DESCRIPTIVE REPORT

Registry No. F00579

General Locality HUMBOLDT BAY

HYDROGRAPHIC SURVEY F00579

Figure 1: Humboldt Bay, Sheet A, multibeam sonar data coverage.

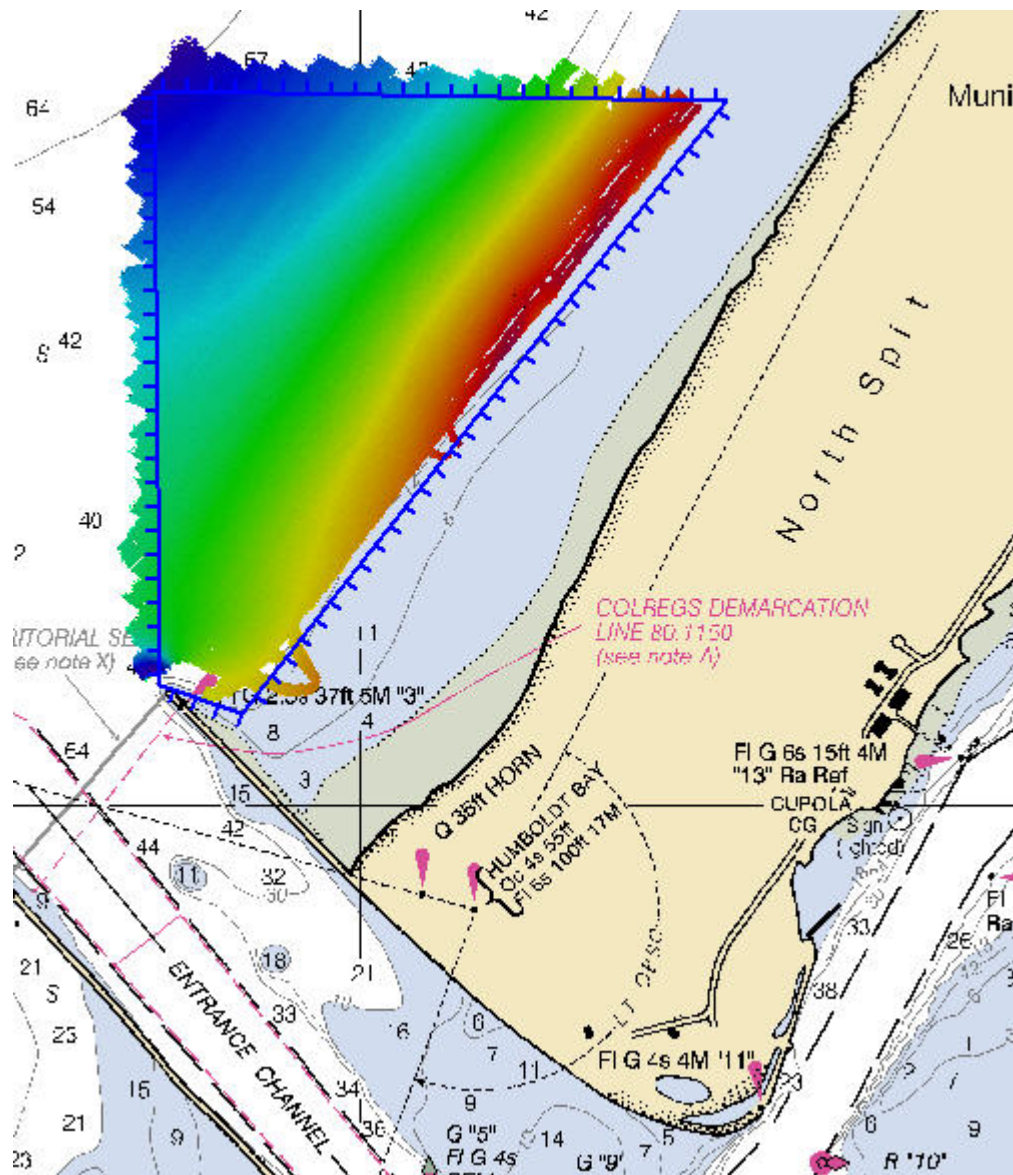
This survey was conducted in accordance with Hydrographic Survey Letter Instructions for Survey F00579, Humboldt Bay, CA. The original instructions are dated September 21, 2009. Data acquisition was conducted from September 8 through September 10, 2009. *Concur.*

See table 1 and figures 1-3 below for acquisition totals, images of survey limits and data coverage.

Figure 4: Final Tide Zoning

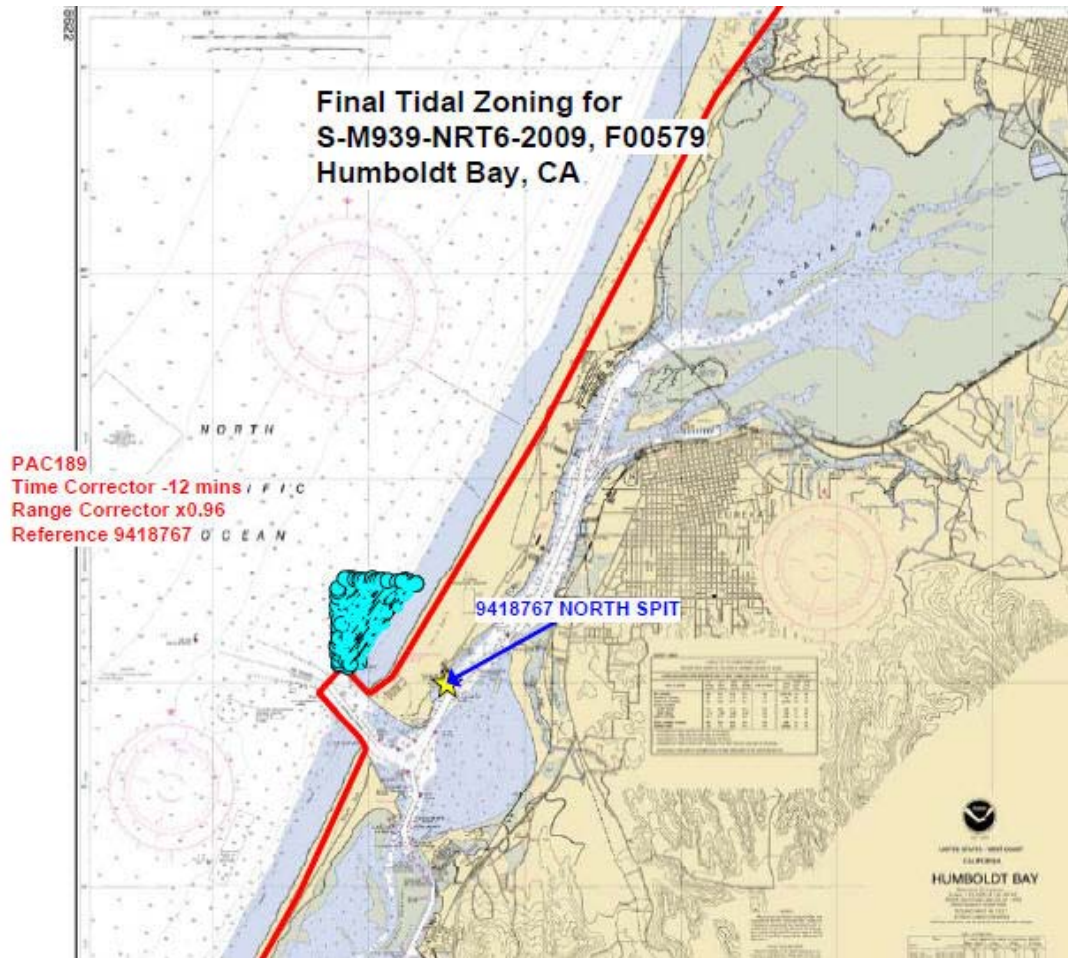
The tidal datum for this project is Mean Lower Low Water (MLLW). The operating National Water Level Observation Network (NWLON) station at North Spit, CA (941-8767) was the sole water level station for this project. See Figure 4 for station location and tide zone boundaries. The tide zoning file “F00579CORF.zdf” was applied during processing. *Concur.*

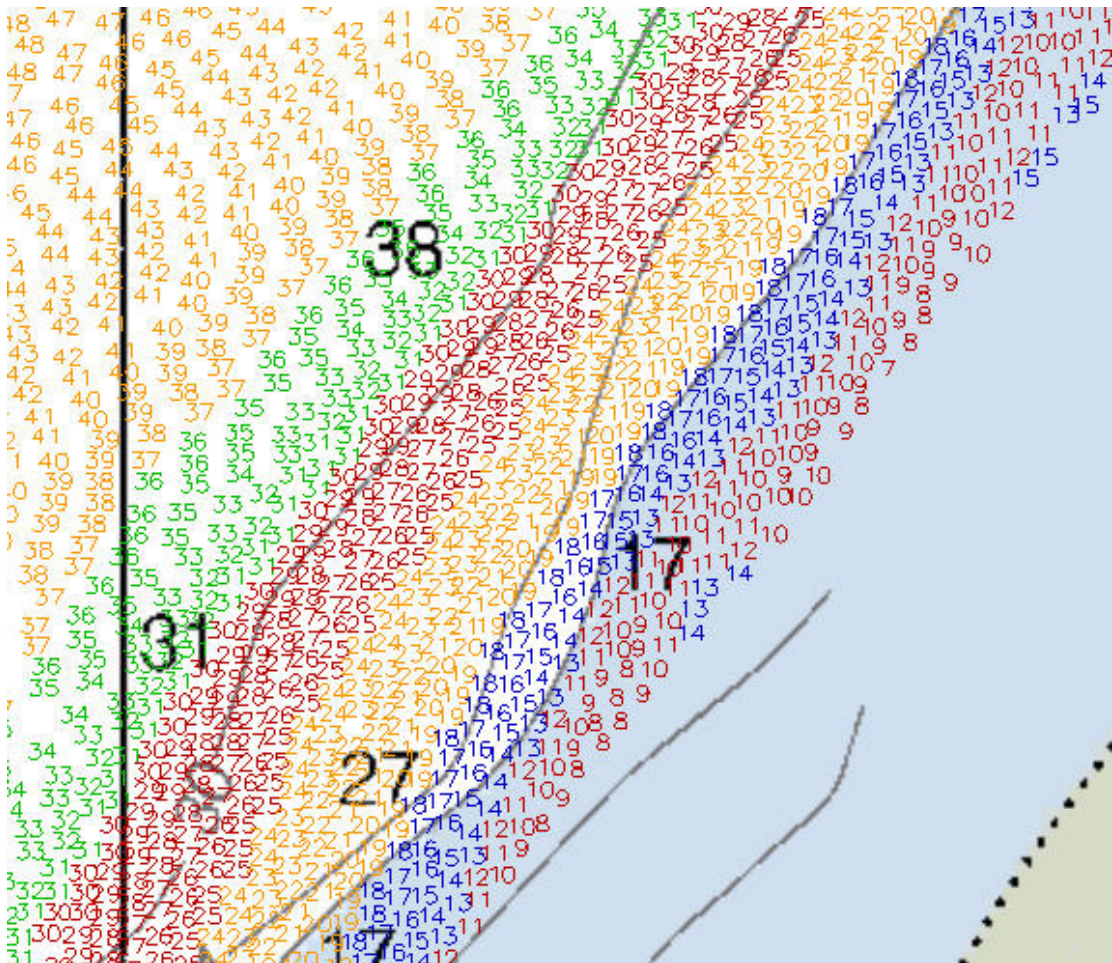
Depths from survey F00579 generally agreed with depths on chart 18622, with exception that the contour lines need to be repositioned to reflect new survey data.

Concur.

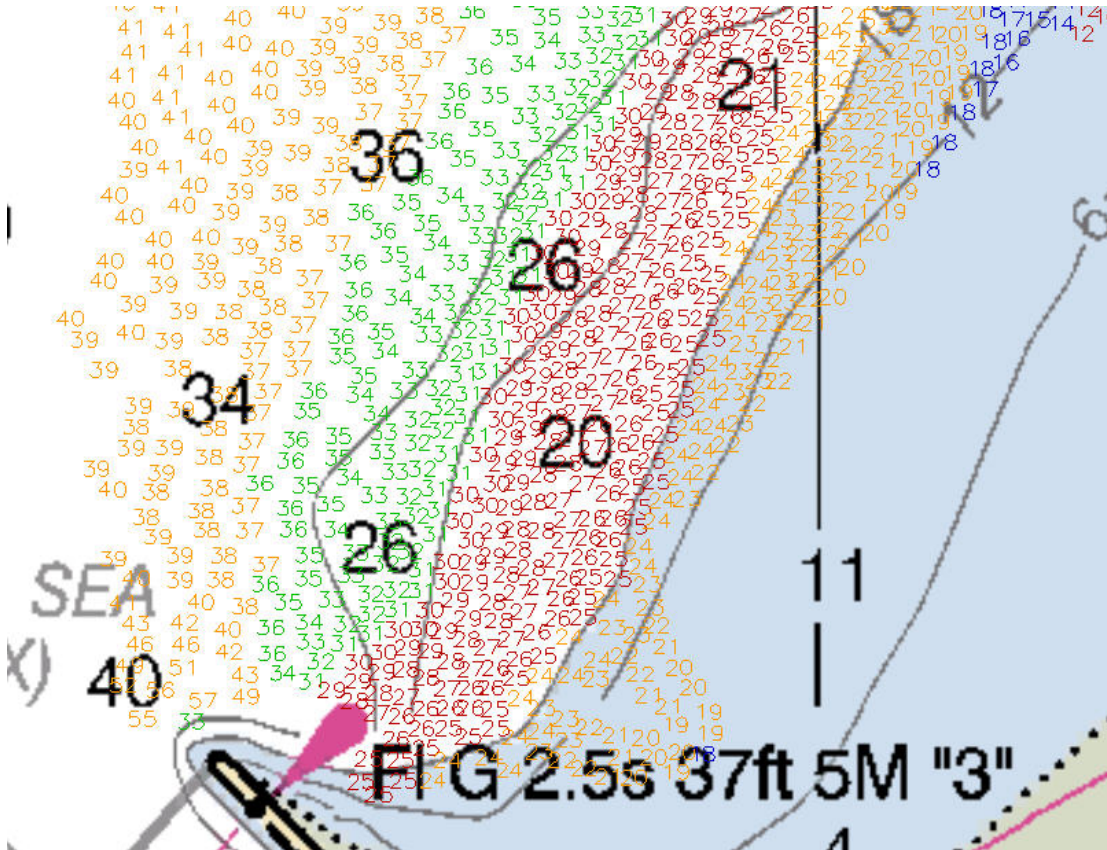
The most apparent and dramatic sounding shifts that have taken place are shown in the images below. **Concur.**

Shoaling as a general trend is most visible in the northeastern portion of the survey area where sediment is drifting and migrating seaward. **Concur.**

In the southern portion of the survey, it appears the jetty is blocking sediment accumulation from its typical northward drift; therefore this area around the jetty is deeper than previously charted. **Concur.**
